BIDS AND AWARDS COMMITTEE

Bid Bulletin No. 4

PROCUREMENT OF CONSTRUCTION OF FIT-OUT AND OTHER WORKS TO COMPLETE OF PHILIPPINE STATISTICS AUTHORITY (PSA) 23-STOREY BUILDING

Question and Answer (as of 25 June 2022)

STUB OUT LOCATION AND EXCAVATION BLOW-UP PLAN

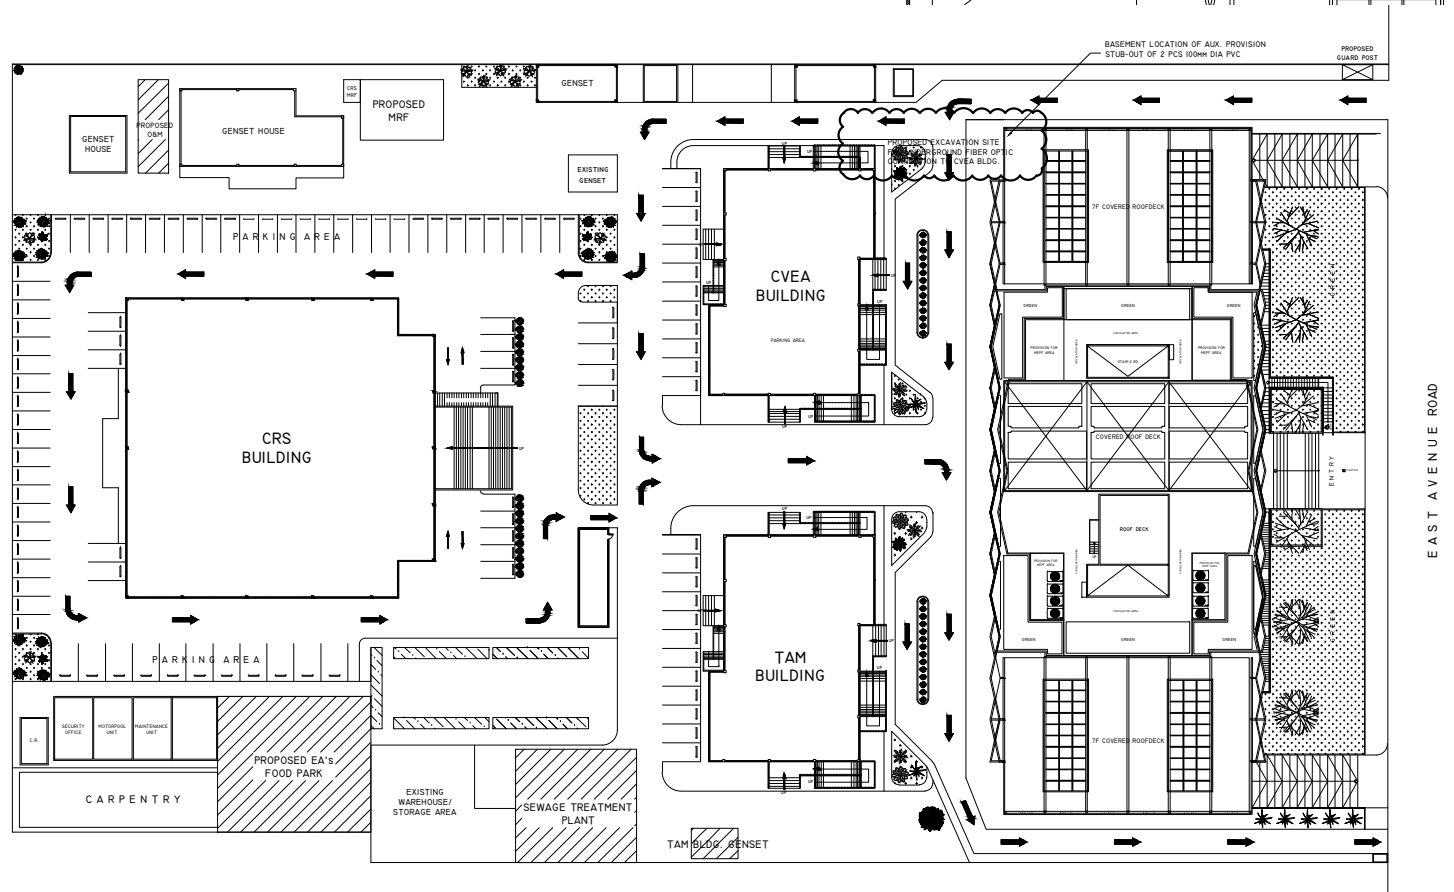
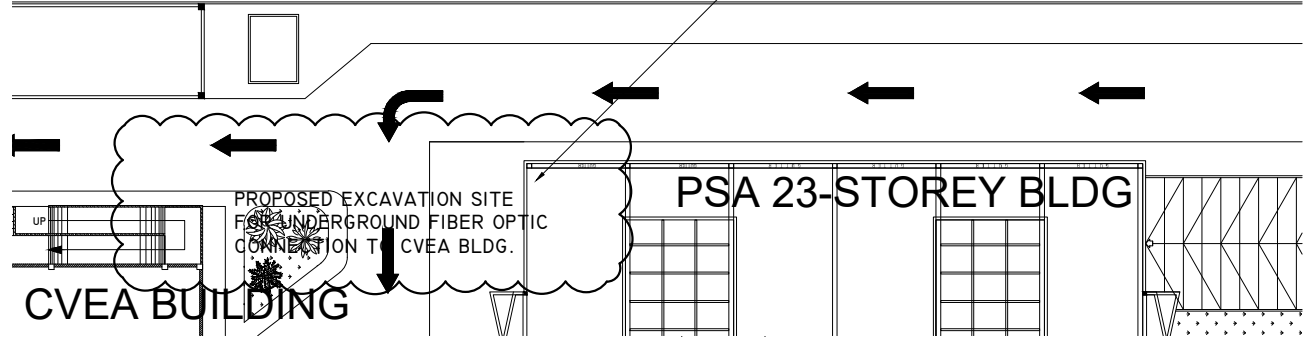
Reference	Amendments /Revision
<p>TOR, Demolition Works</p> <p>The excavation details from CVEA to 23/F building?</p>	<p>There are 2 provisioned exit points of fiber optic from the 23 storey building. The fiber optic cable connected to the main distributor and redundant main distributor must use separate exit points and underground conduit going to CVEA building for fiber optic redundancy.</p> <p>Please see Fiber Optic layout from CVEA to 23 Storey Building</p> <p>Please see attached excavation details.</p>
<p>Section IX, Checklist of Technical and Financial Requirements</p> <p>Please provide a template for the FORM 1 under the bid form for FINANCIAL DOCUMENTS.</p>	<p>Please see attached Financial Proposal Form.</p>
<p>Terms of Reference, Civil Works</p> <p>Please provide structural plan for the G/F Mezzanine</p>	<p>See attached Structural Plan for the G/F Mezzanine.</p>
<p>Terms of Reference, Civil Works</p> <p>As per Site inspection, Structural Framings for Basketball court Roofing is not yet existing. Please confirm if it will be part of the scope. If yes please provide structural plans.</p>	<p>Yes, it is part of the scope. See attached Structural Framings for Basketball Court.</p>

2nd Floor CVEA Building

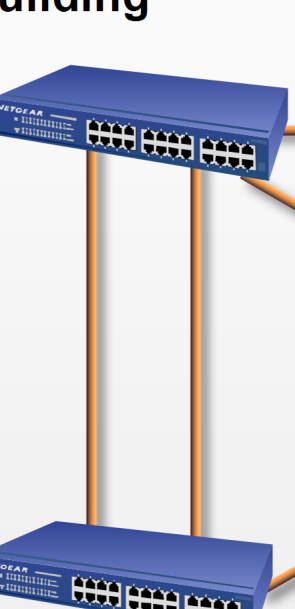
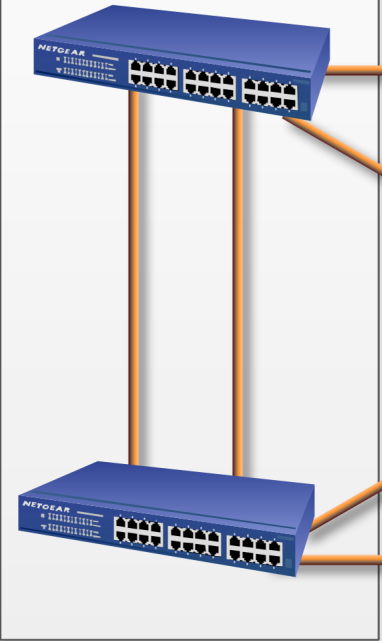
<p>The detailed Single Line or Network Equipment Diagram for the Inter connection between PSA 23 floors to CVEA Bldg. for us to know the detailed connectivity in between floors and in between campus backbone for the redundancy of fiber and network equipment.</p>	<p>distributor switch should have switch stacking capability and must have fiber optic cable connected directly to both main distributor switches for redundancy.</p> <p>Please see fiber optic connection From CVEA to 23 Storey Building and going to floor distribution switches.</p>
------------------------------------------------------------------------------------------------------------------------------------------------------------------------------------------------------------------------------------------------------------------------	------------------------------------------------------------------------------------------------------------------------------------------------------------------------------------------------------------------------------------------------------------------------------------------
